Additional Information with respect
to the development at Lands at
Forest Road, Swords, Co. Dublin

ADDITIONAL INFORMATION

Condition 9 of Reg Ref: LRD0057/S3E

Client: Golden Port Homes Limited

Additional Information 1.a) and 1.c) v):

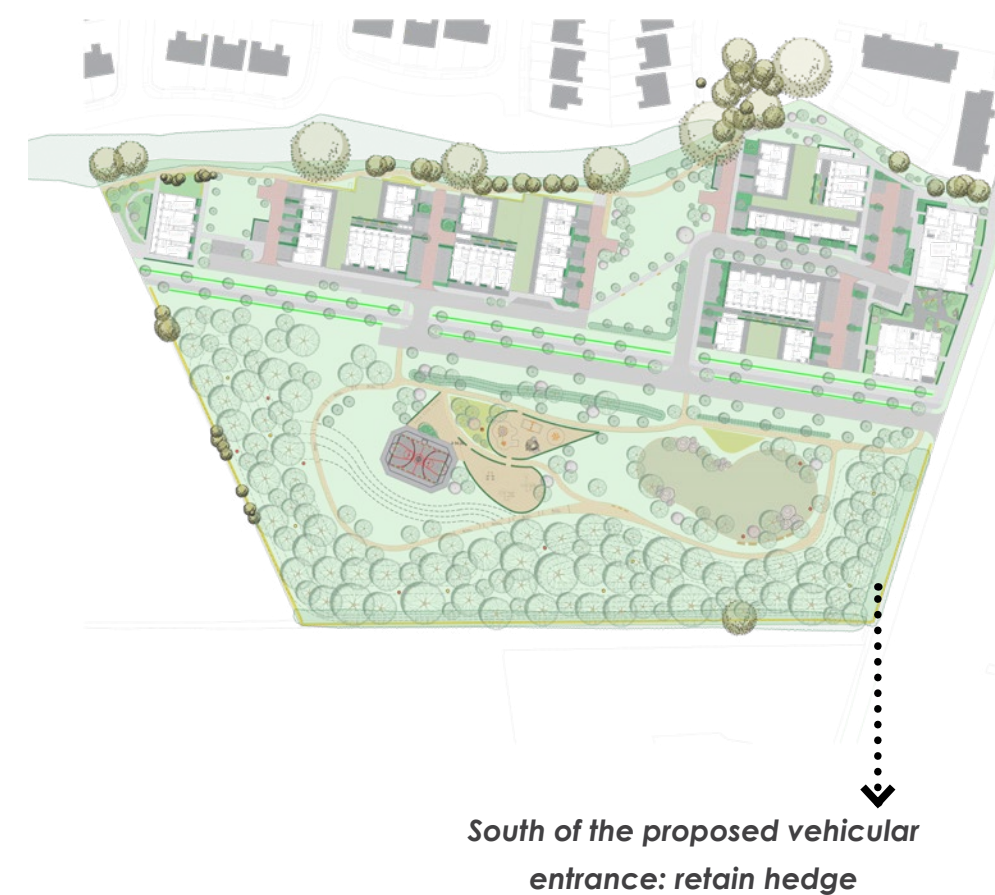
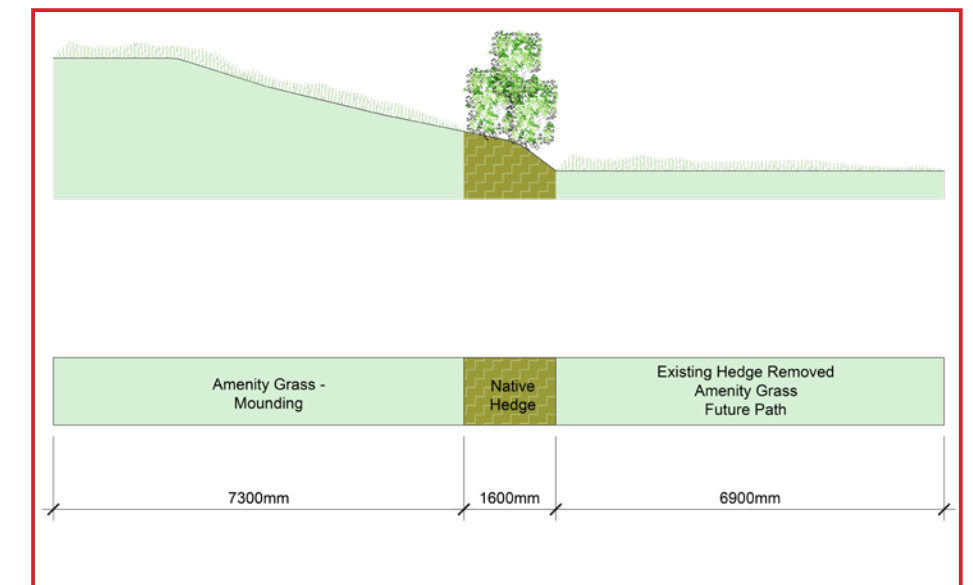
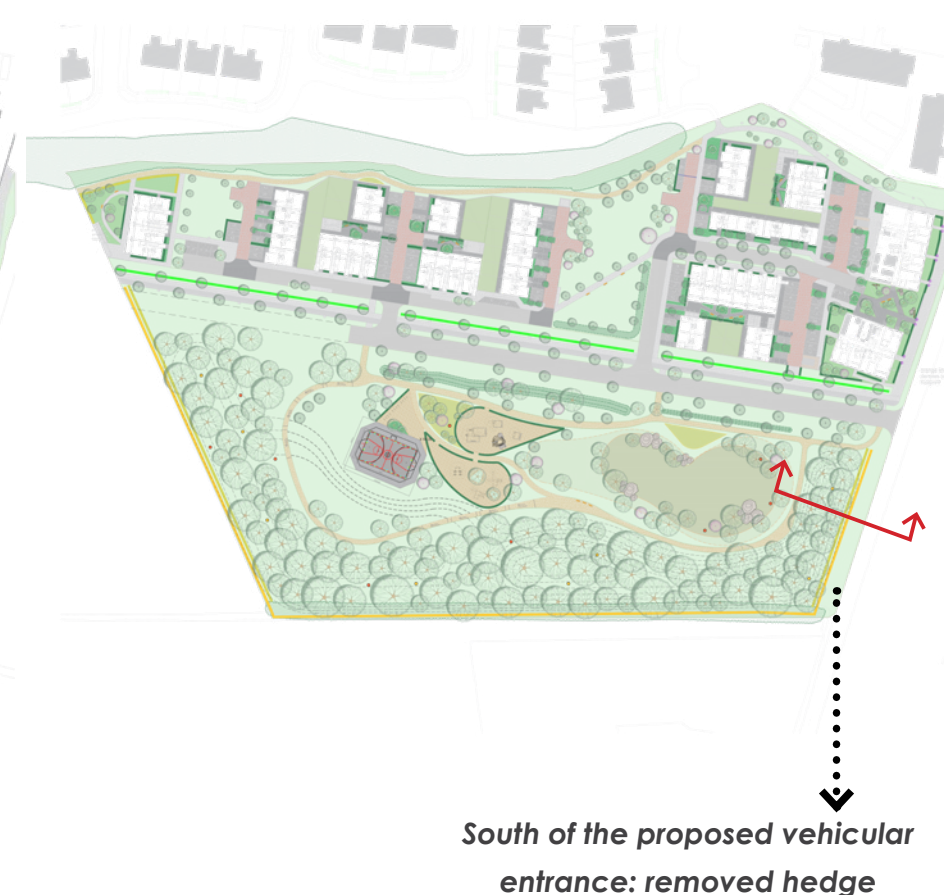
a) The applicant is requested to address the sightliness to the South of the proposed vehicular entrance. From a site visit it was observed that the sightliness to the south are obscured by the existing hedge, and could be further obscured overtime due to future growth of the hedge. The applicant is request to provide a drawing detailing all works required to the existing hedge and any proposed replanting/boundary works. The applicant should take cognisance that the posted speed limit of the road is 60km/hr.

c) v) Submit revised layout plan showing the proposed hedging in the verge along the 'link road'/proposed new distributos road set back to ensure it does not obscure sightlines at the junctions and would not encroach into the road carriageway over time.

The hedge has been removed from the proposed layout in order to prevent any obstruction to sightliness.

Additional Information 1.d):

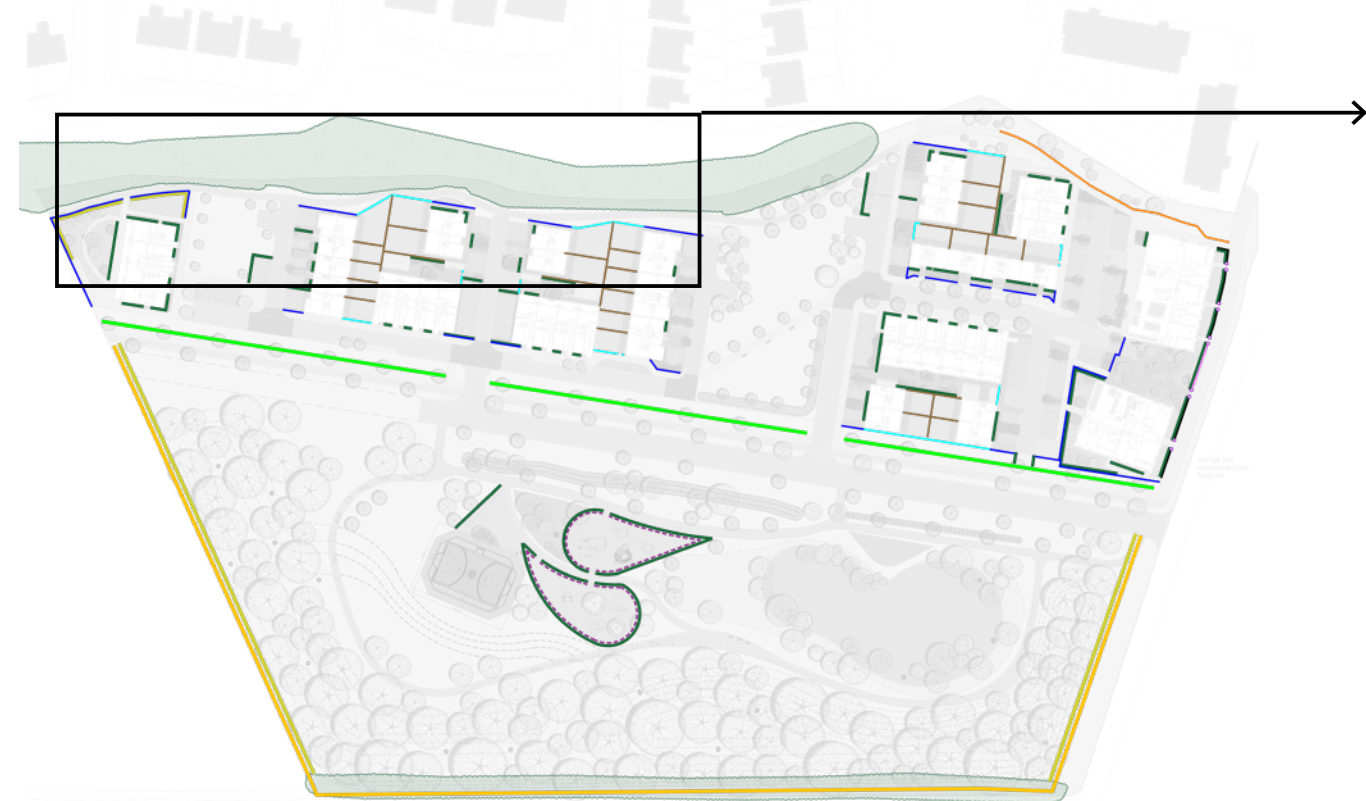
d) A revised layout plan which illustrates a 'road reservation corridor' between the end of the proposed new distributor road and the western site boundary. This area to be maintained as grass with no tree or other planting on it.

The hedge has been omitted from the proposed layout in order to prevent any obstruction to sightlines at the junction.

Road Reservation Corridor to be
maintain as grass with no tree or other
planting

Boundary Plan

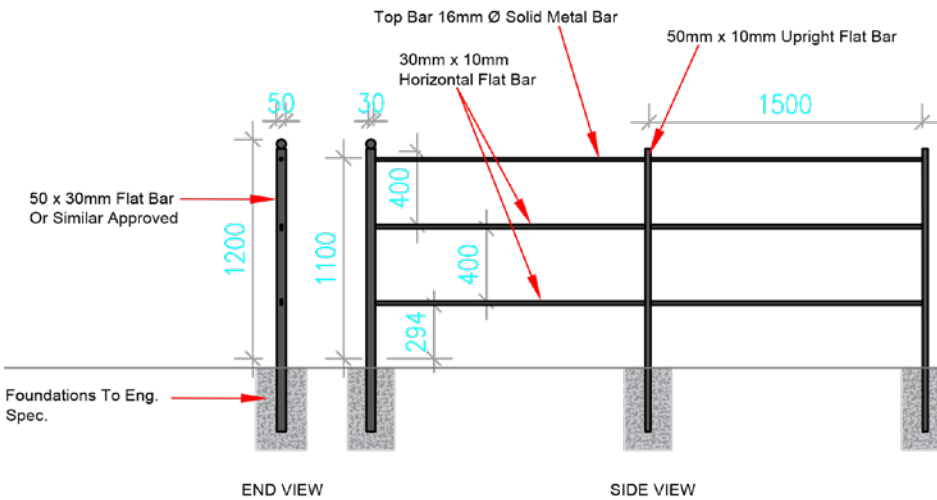
The applicant is request to submit revised proposals for the development layout to provide for increase surveillance of Open Space to the north. The dominance of rear garden boundaries along the northern edge limits passive surveillance of Open Space to the north. The dominance of rear garden boundaries along the northern edge limits passive surveillance, increasing vulnerability, and stepped rear garden will create unsupervised spaces, increasing vulnerability to anti-social behaviour, and the rear gardens themselves may also become targets due to their exposure

Passive surveillance to the north has been enhanced by replacing the previously proposed 2 m high walls with 1.2 m high railings. In addition, the boundary walls have been realigned to eliminate stepped areas, thereby removing potential hiding spaces.

Area A - Original layout - REV O

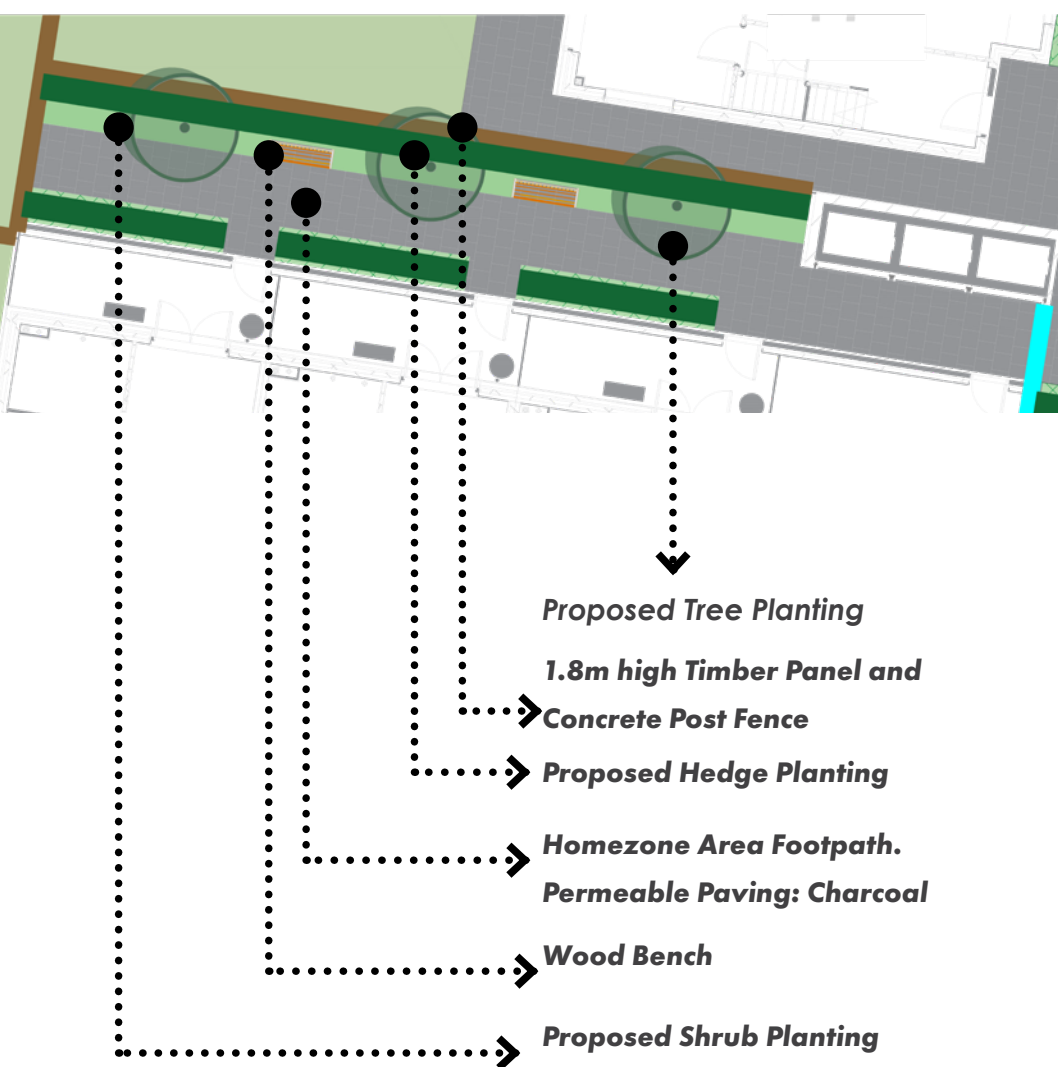
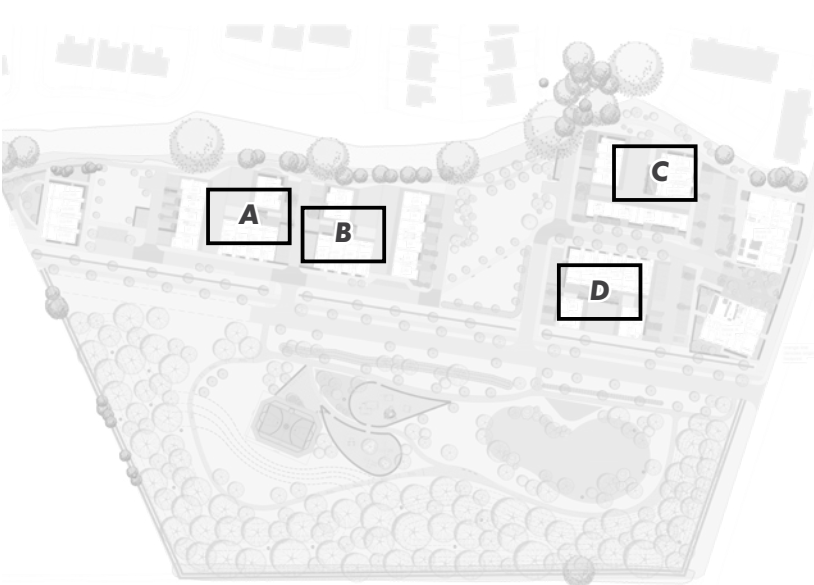
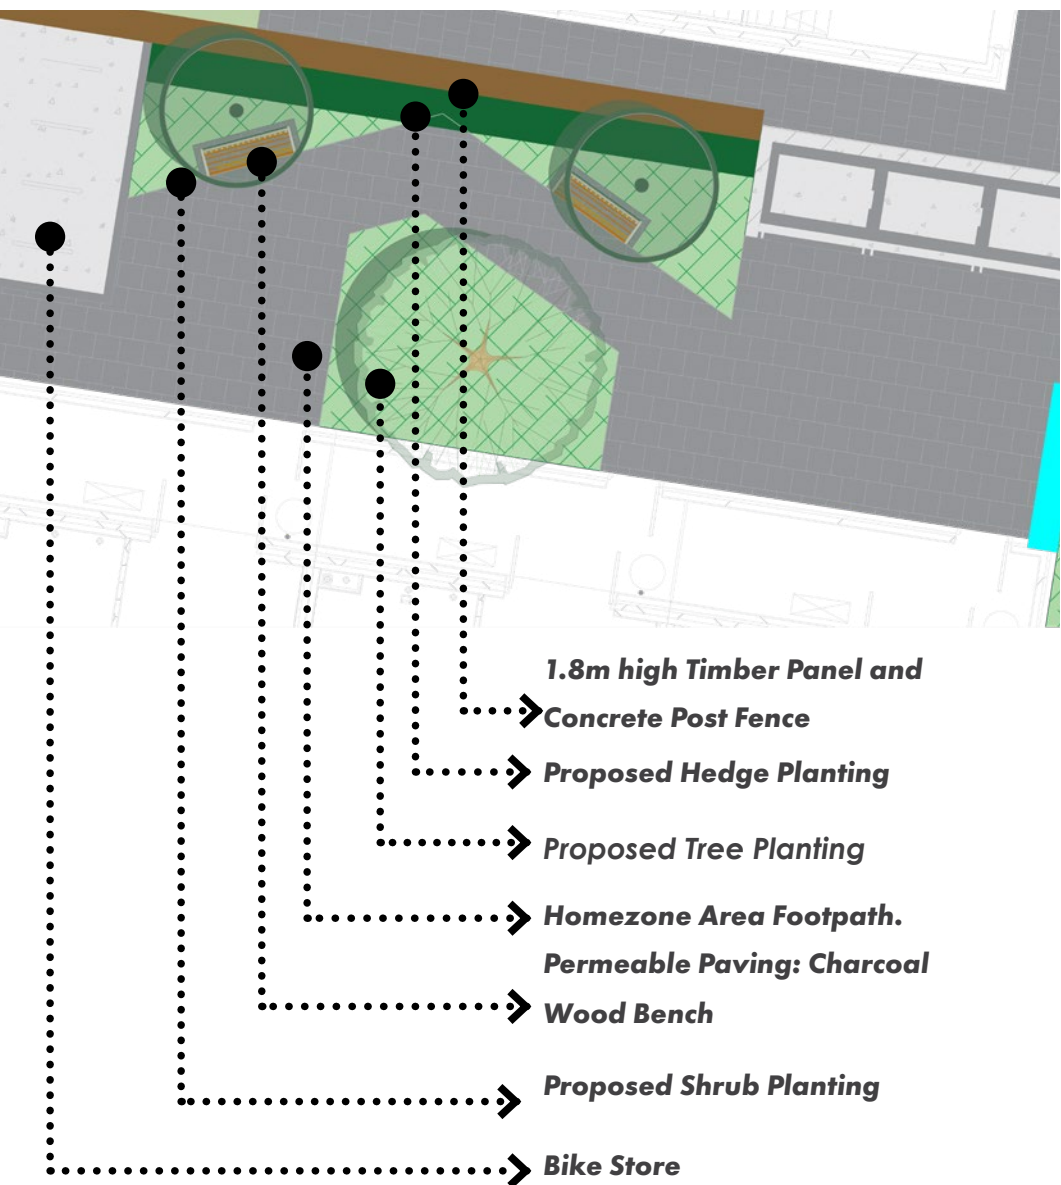
Based on the 'Daylight and Sunlight Assessment Report' submitted, the communal open spaces serving duplex units in zones B, C and D would not achieve compliance with BRE Guidelines in respect of sunlight. Furthermore, having regard to the layout and dimension of these spaces and the spaces in Zone A and serving Block B, the Planning Authority is not satisfied that a satisfactory standard of residential amenity would be afforded to future residents. The applicant is requested to submit a revised layout to address this.

The communal open spaces in Zones A, B, C, and D, as referenced in the Daylight and Sunlight Assessment Report, have been reviewed and subsequently modified through revised landscape design in order to address the concerns raised and to enhance the overall residential amenity for future occupants. Please find enclosed at this stage a diagram in this regard.

Area B - Original layout - REV O

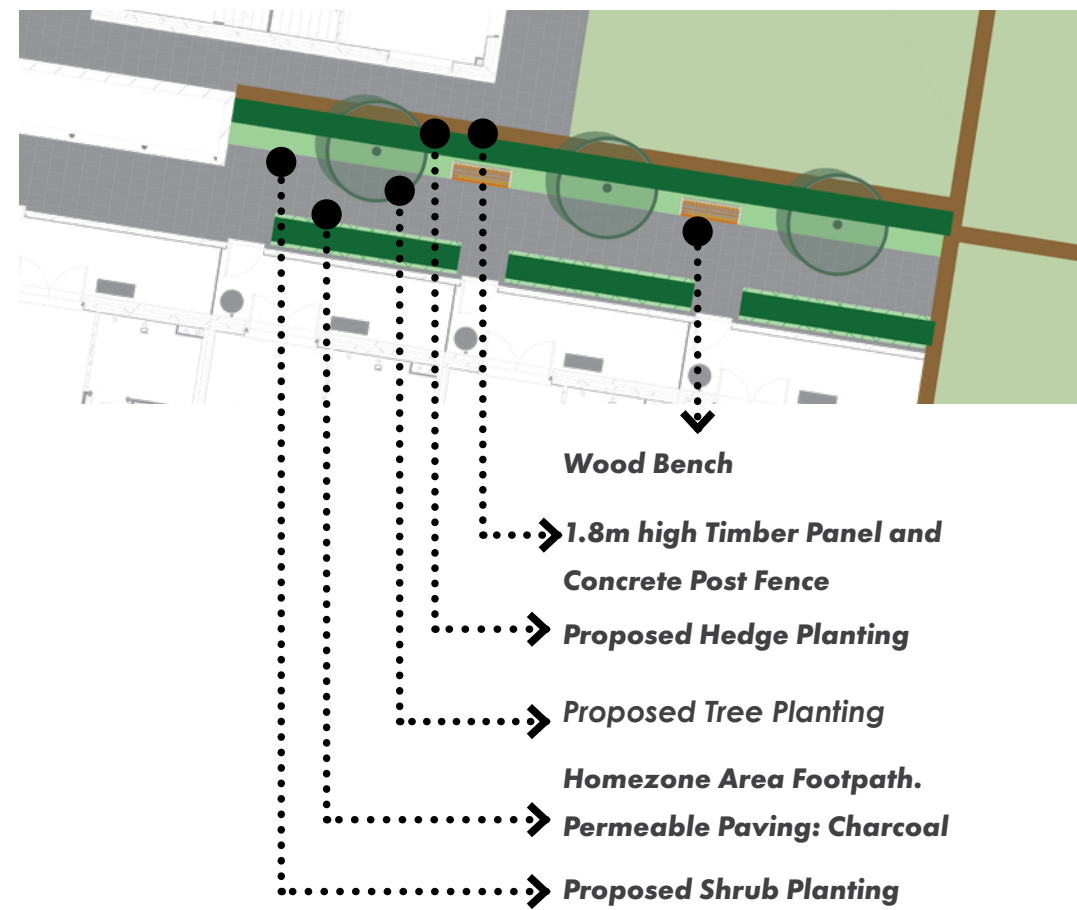
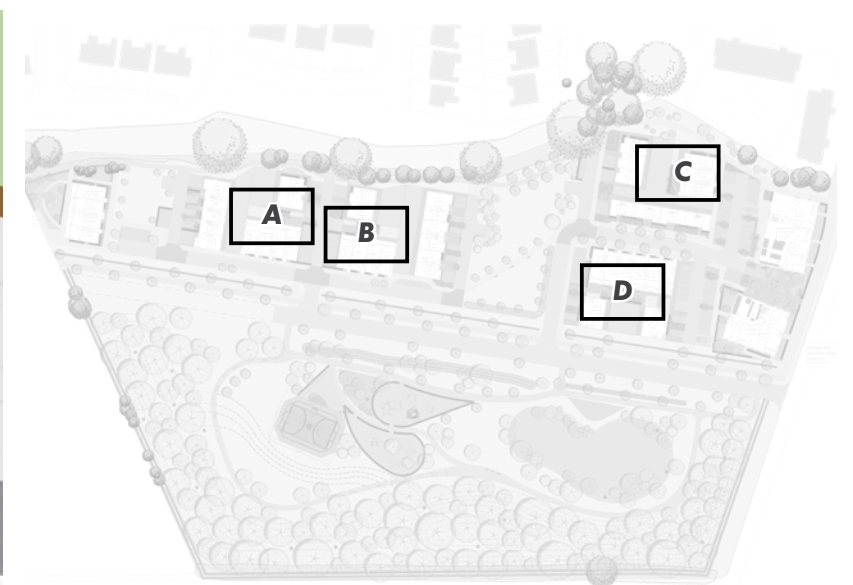
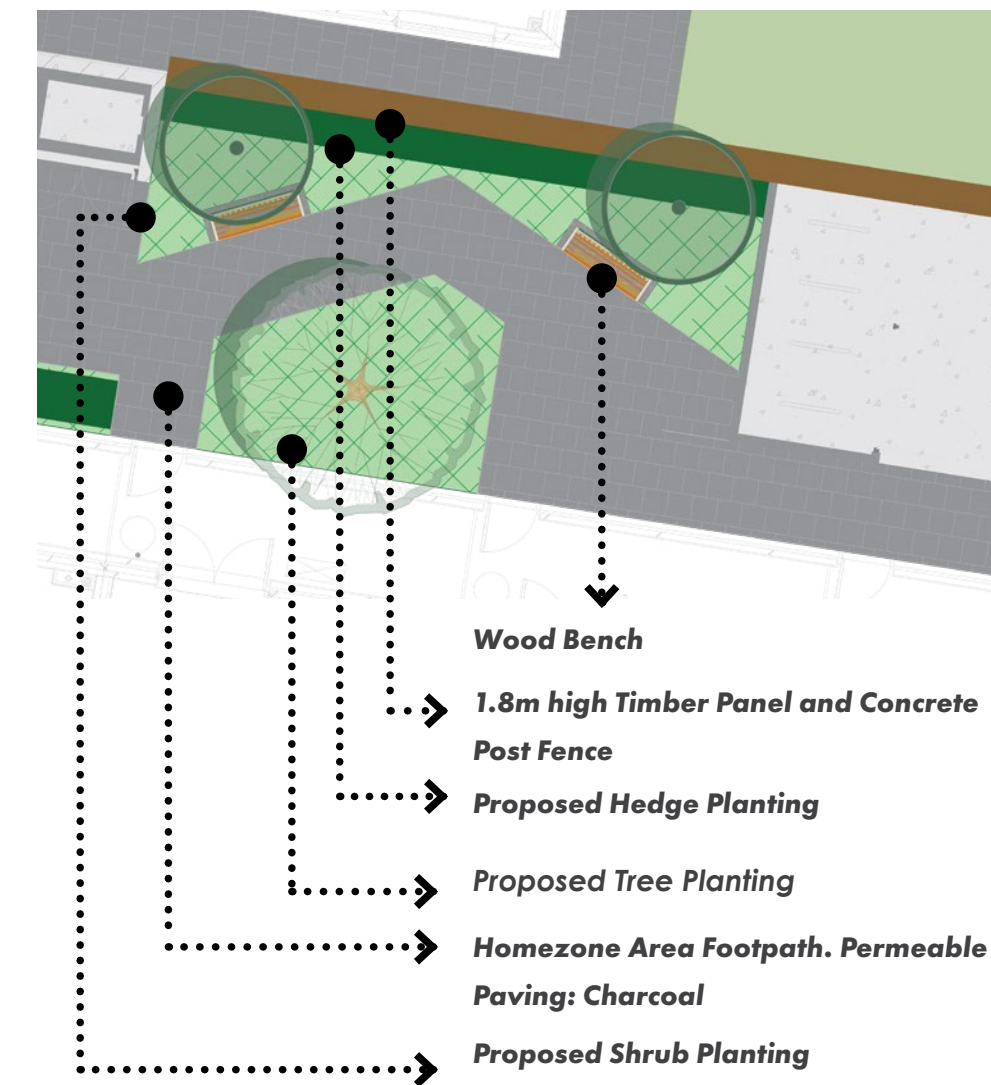
Based on the 'Daylight and Sunlight Assessment Report' submitted, the communal open spaces serving duplex units in zones B, C and D would not achieve compliance with BRE Guidelines in respect of sunlight. Furthermore, having regard to the layout and dimension of these spaces and the spaces in Zone A and serving Block B, the Planning Authority is not satisfied that a satisfactory standard of residential amenity would be afforded to future residents. The applicant is requested to submit a revised layout to address this.

The communal open spaces in Zones A, B, C, and D, as referenced in the Daylight and Sunlight Assessment Report, have been reviewed and subsequently modified through revised landscape design in order to address the concerns raised and to enhance the overall residential amenity for future occupants. Please find enclosed at this stage a diagram in this regard.
